Serial No. NA3-08-079R
Docket No. 52-017
COL/LTB

DOMINION VIRGINIA POWER
NORTH ANNA UNIT 3 COMBINED LICENSE APPLICATION
RESPONSE TO REQUEST FOR ADDITIONAL INFORMATION REGARDING THE
ENVIRONMENTAL REVIEW

On June 18, 2008, NRC requested additional information to support the review of certain portions of the North Anna Unit 3 Combined License Application (COLA). The responses to the following RAIs are provided as enclosures to this letter:

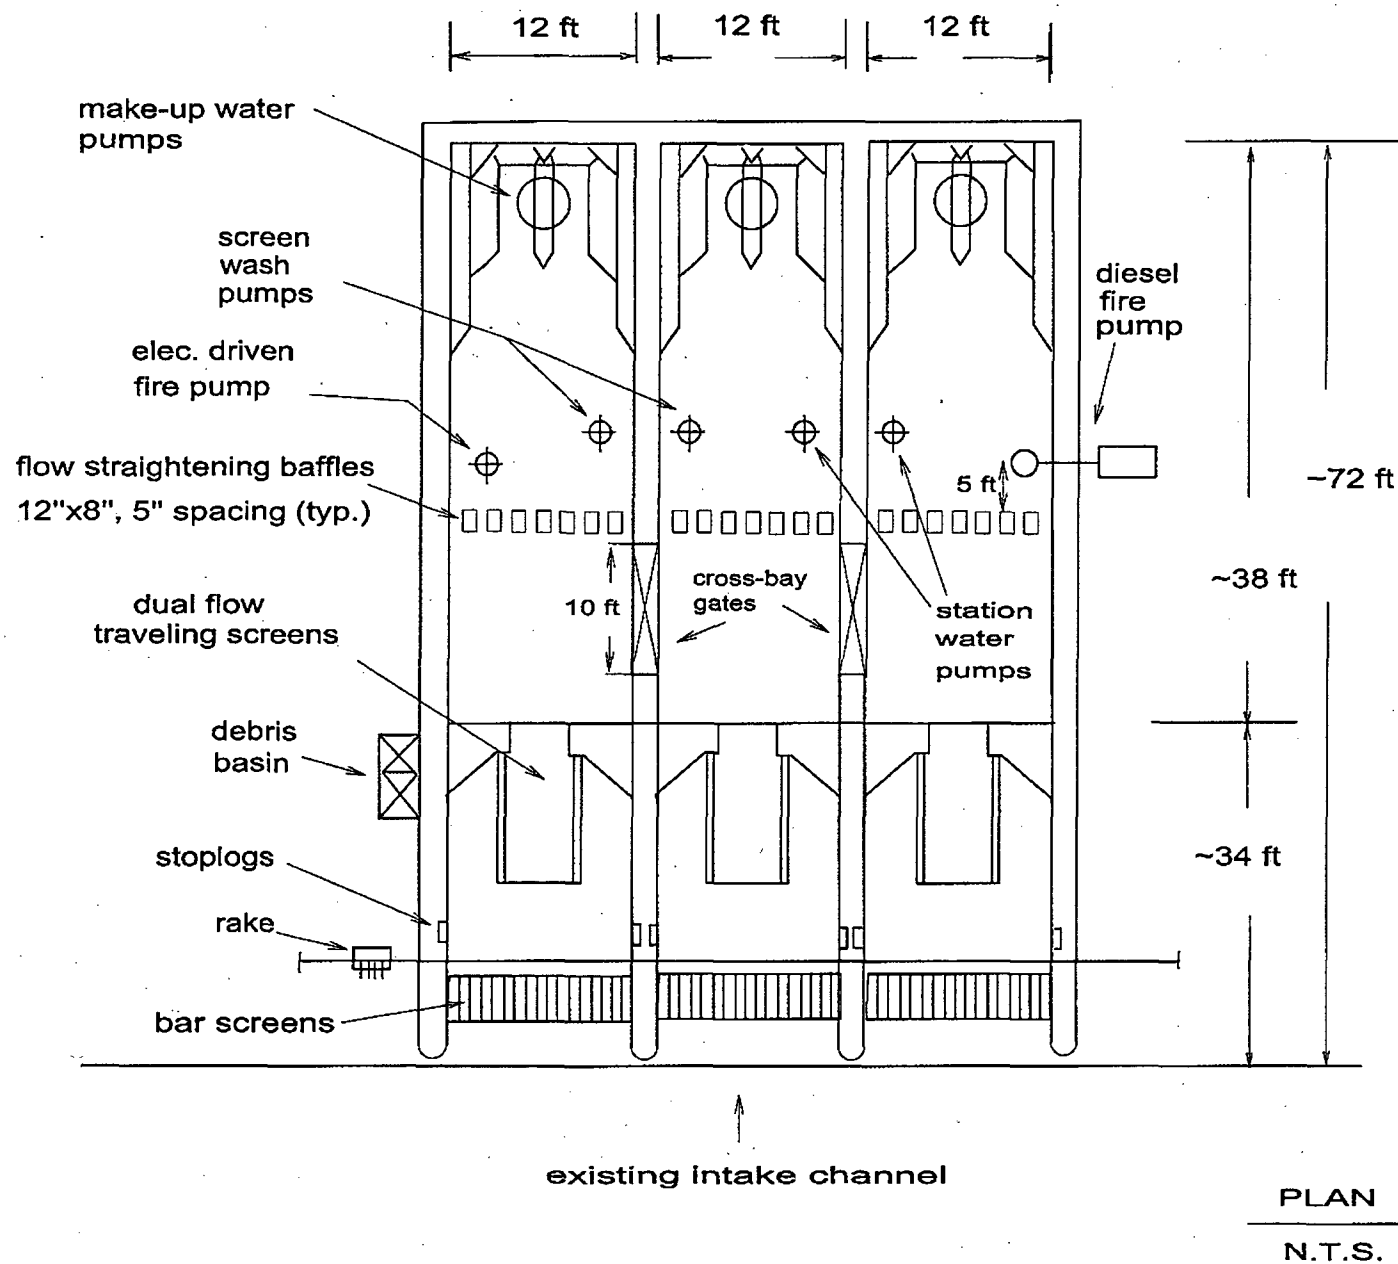
ER Section 3.4-1: To the extent information is available describe the Unit 3 Intake design, including the lagoon and any culverts through the coffer dam, and the new intake structure dimensions, the design flow velocity, the fish screens, and other features. Provide updated figures of the intake area (plan view), the planned intake structure, and flow path.

The Unit 3 intake structure withdraws water from Lake Anna to supply the plant's water needs. It has three pump/screen bays and is designed to accommodate the following combination of pumps:

To protect the pumps from debris, the entrance opening of the intake structure is equipped with trash racks and raking mechanism. Downstream of the trash racks, there are three sets of dual flow traveling water screens, each with an 8-ft basket width and a 2 mm screen mesh size. The maximum flow-through velocity at the openings of the trash racks and the traveling water screens is designed to be less than 0.5 ft/sec. Figures 1a and 1b are schematic sketches that illustrate the principal hydraulic dimensions of the intake structure. Minor adjustments of the intake dimensions are expected to be necessary during detailed design stage to accommodate the size of equipment (pumps and screens) specified by the suppliers.

RAI ER Section 2.4-1 Enclosure 1 - Figure 1

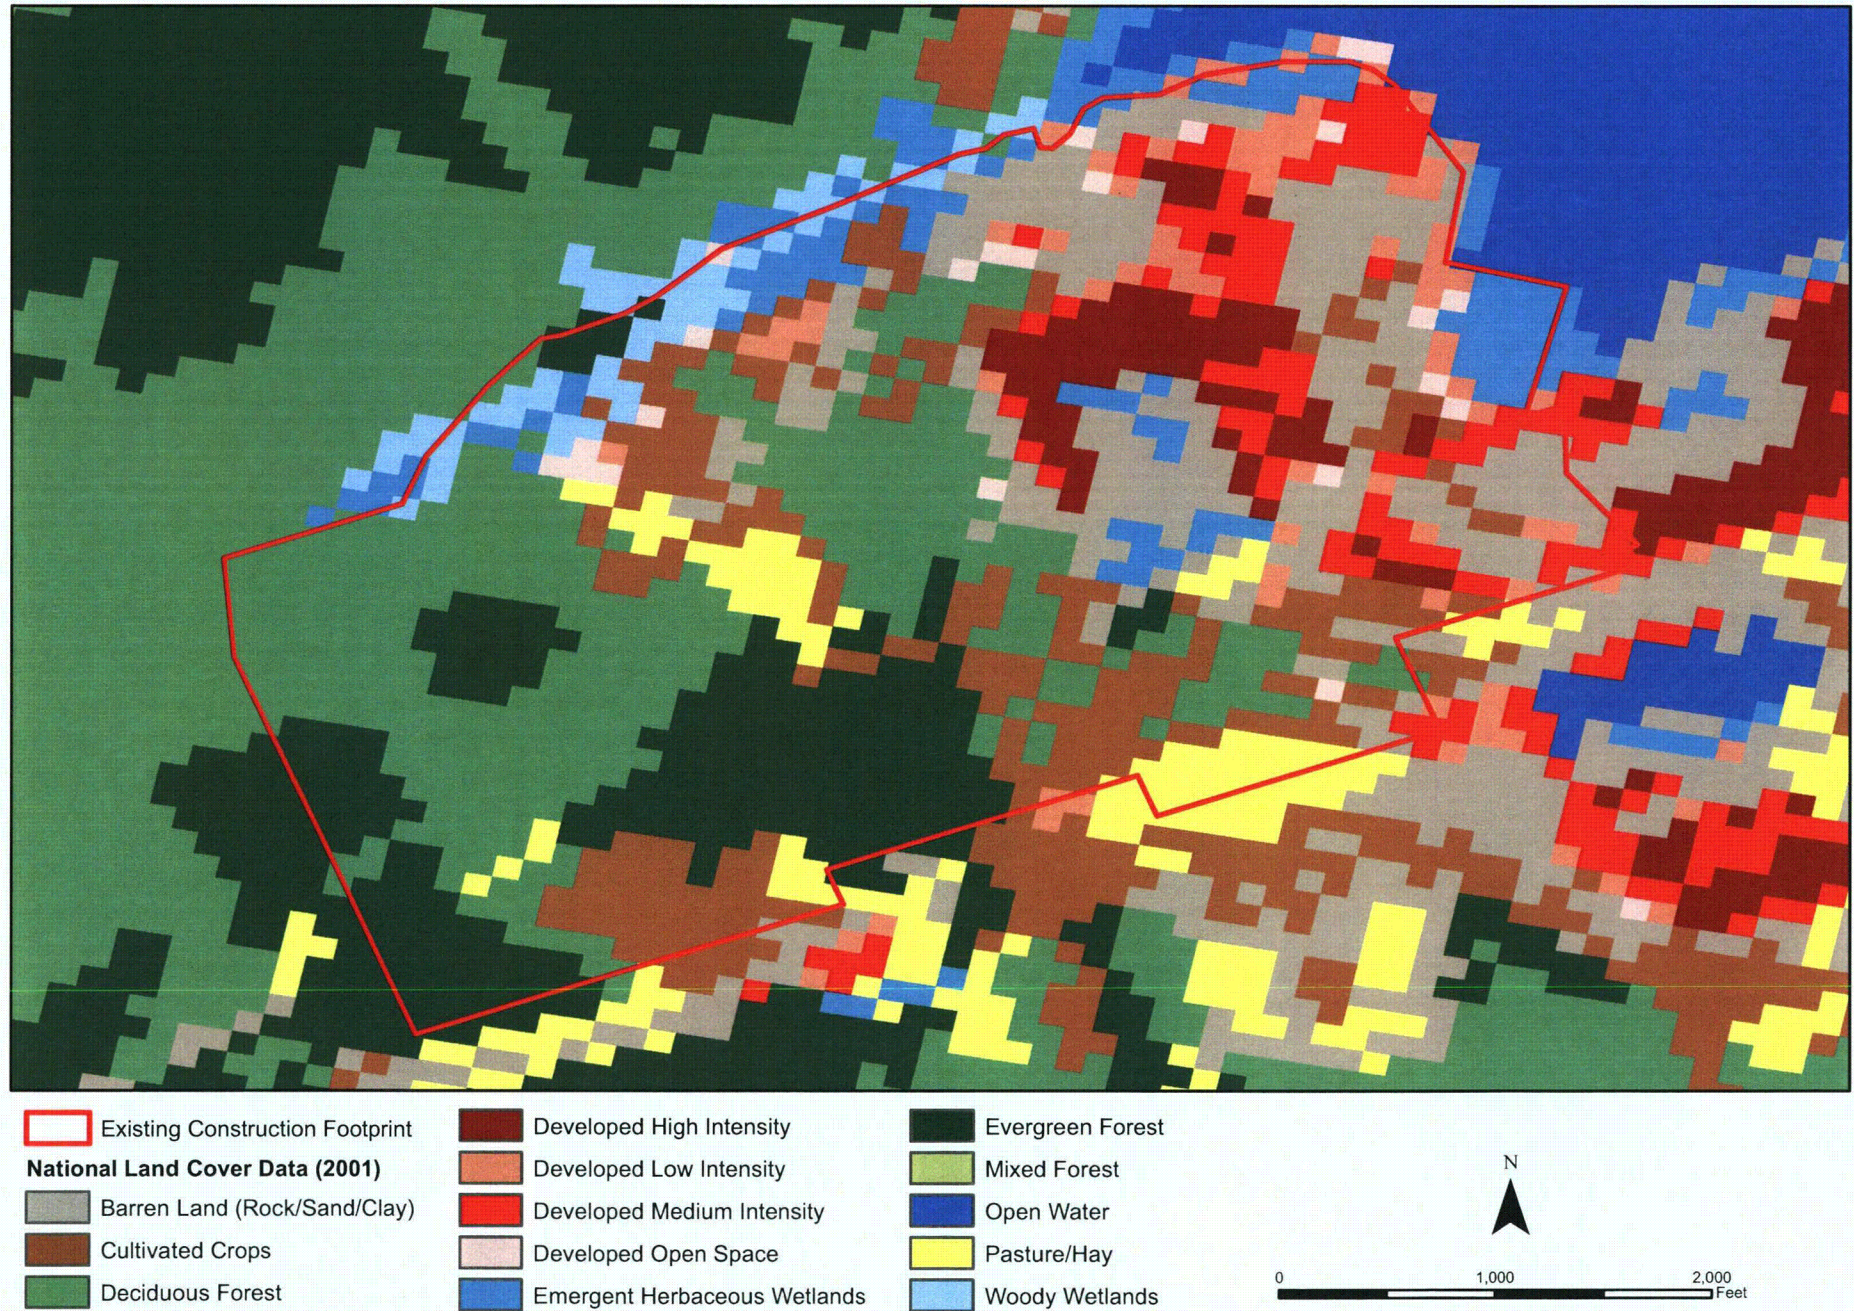
Provide updated accounting of habitat types within the construction footprint, the total size of the footprint, and the number of acres of each habitat type within the footprint. Describe the proportion that will be permanently and temporarily impacted by habitat type. Provide an overlay of the construction footprint on a habitat map of the site.

A habitat map of this area is provided as Figure 1 of this enclosure. Figure 2 of this enclosure provides an overlay of this area on a habitat map of the site.

Based on a review by biologists familiar with the NAPS site of the habitat map generated with the NLCD, it appears that many of the mown areas on the site are incorrectly classified by this mapping program as pasture/hay or cultivated crops. See for example, the "cultivated crops" and "pasture/hay" classifications under the transmission lines, adjacent to the Independent Spent Fuel Storage Installation, and at the location of the primary meteorological tower on Figure 2. These are actually large swaths of lawn or mown vegetation.

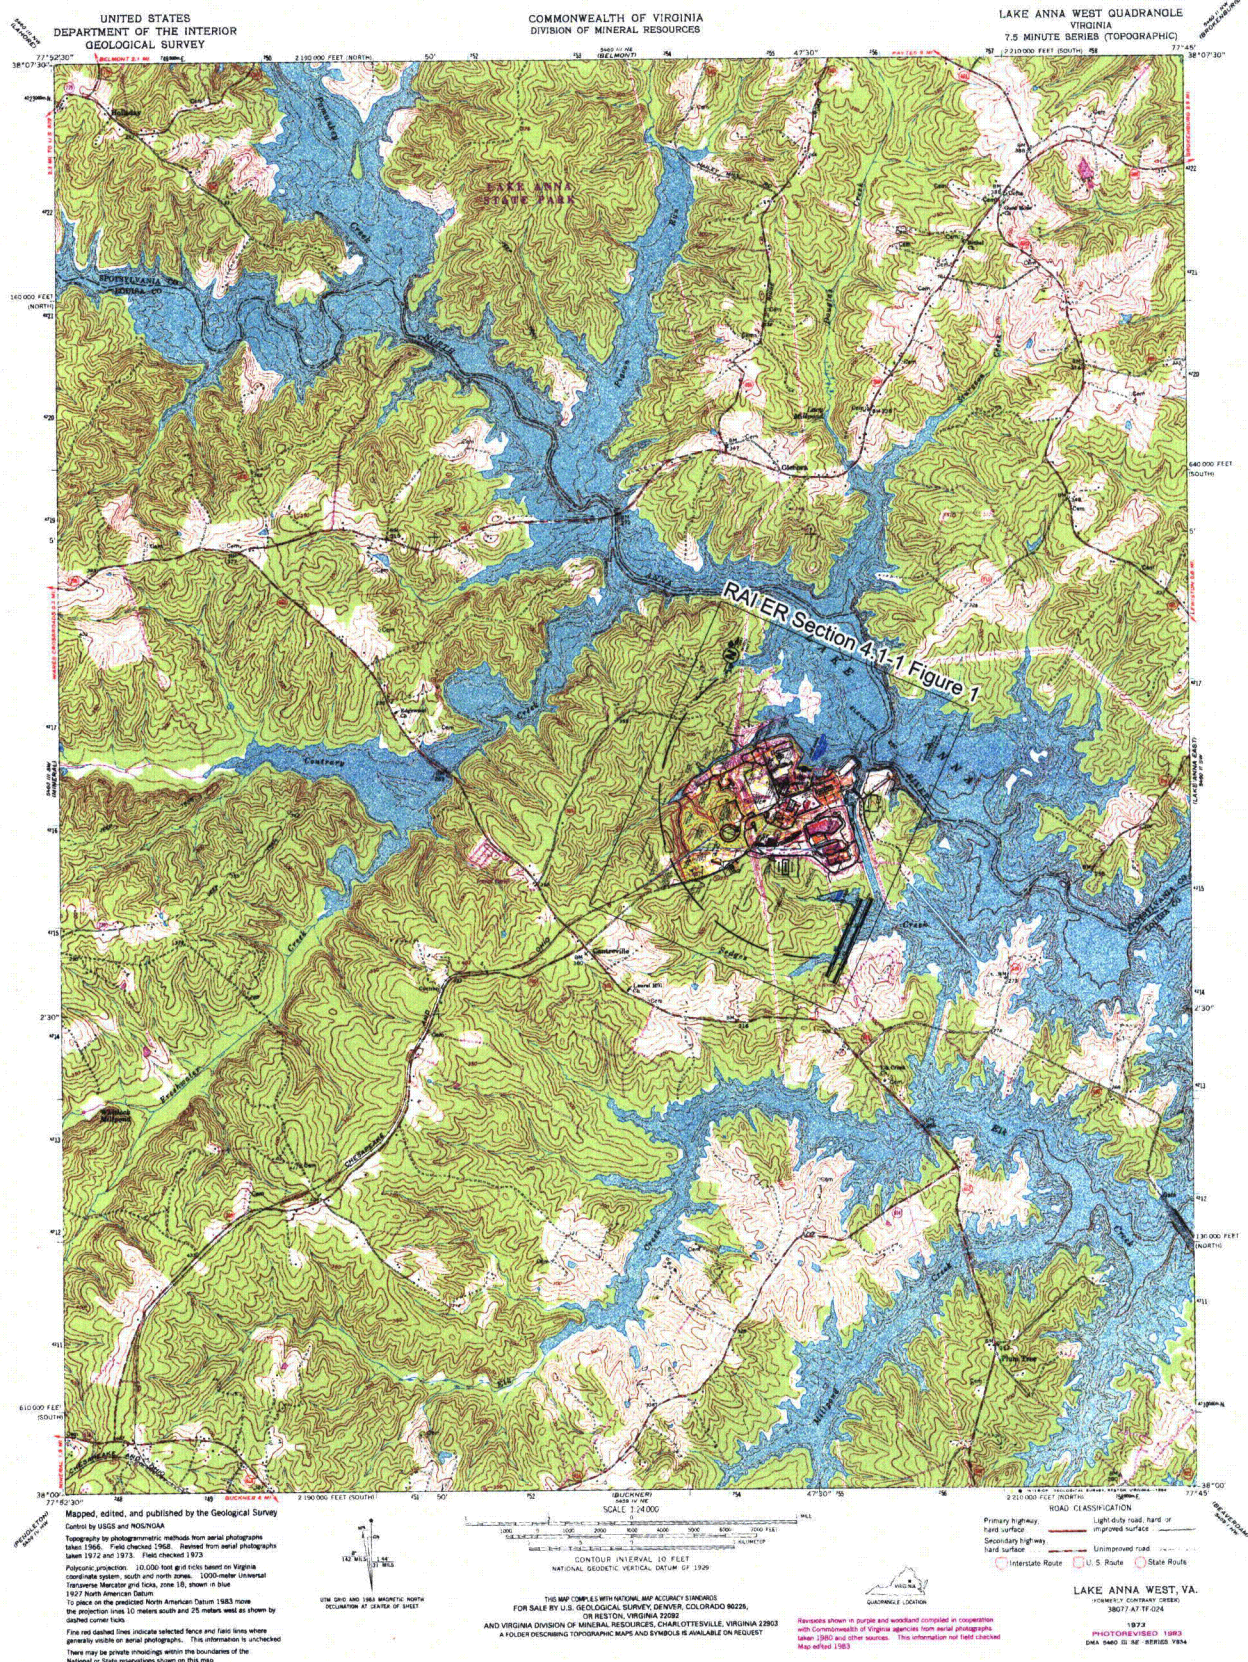
Provide a USGS 7.5 minute map with construction boundaries (including lay down areas) and cultural survey areas.

The enclosed two figures provide the information requested. Figure 1 is a "zoom-in" of the North Anna site overlaid on a USGS contour map, fit to better show construction and cultural resources areas. Figure 2 is the full 7.5 minute USGS Lake Anna West Quadrangle map with the Figure 1 overlay. Please note that the "construction boundaries" shown on this figure only delimit the on-site areas that will be used for Unit 3 facilities and construction support facilities and activities, and do not include (1) areas that may be impacted as a result of additions and modifications to facilities supporting Units 1 and 2, (2) the NAPS-to-Ladysmith transmission corridor, and (3) [
